1 Products affected

2 Type of change

Product Change Notification					PCN Fusedrawer 2		
owner	creation date	release date	released by	change order no	rev	page	D10-017-137
sariogar	21.09.2017	22.09.2017	buerglal	2013754	C	1 of 3

Old fusedrawer design	New fusedrawer design

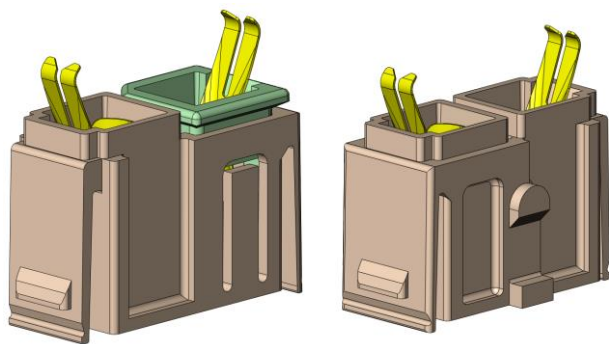
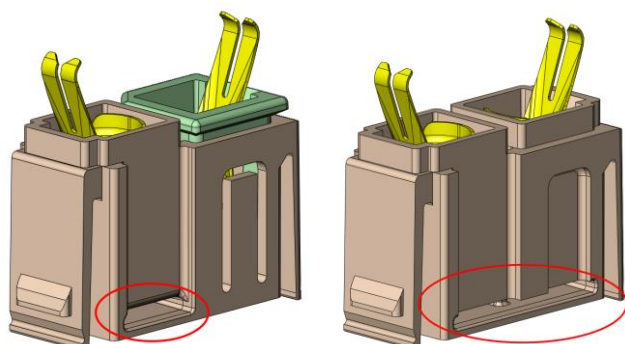
Change of fusedrawer design (additional air gap)

- Improvement of thermal behaviour by addition of air insulation between fuse carrying contact spring and touchable surface

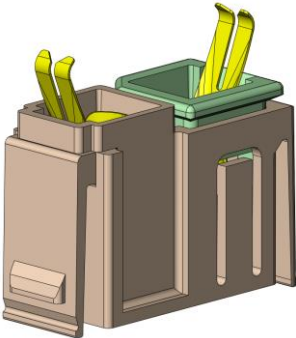
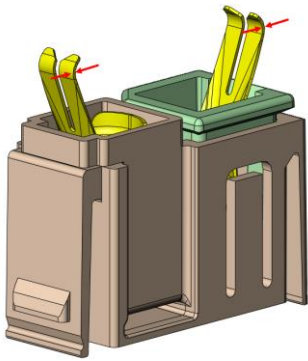
Old contact spring thickness 0.20 mm	New contact spring thickness 0.25 mm

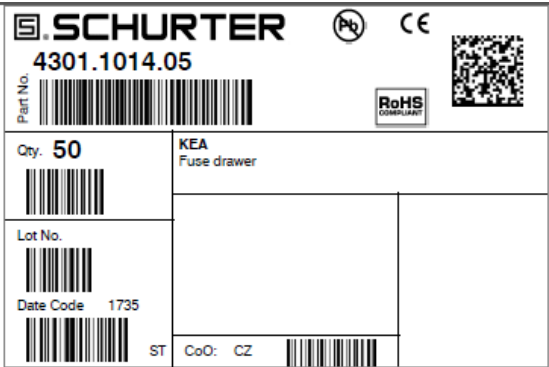
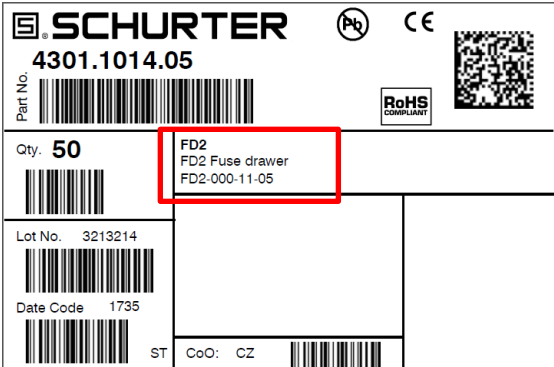
Old label	New label
	Name and description adjusted. Configuration code added.
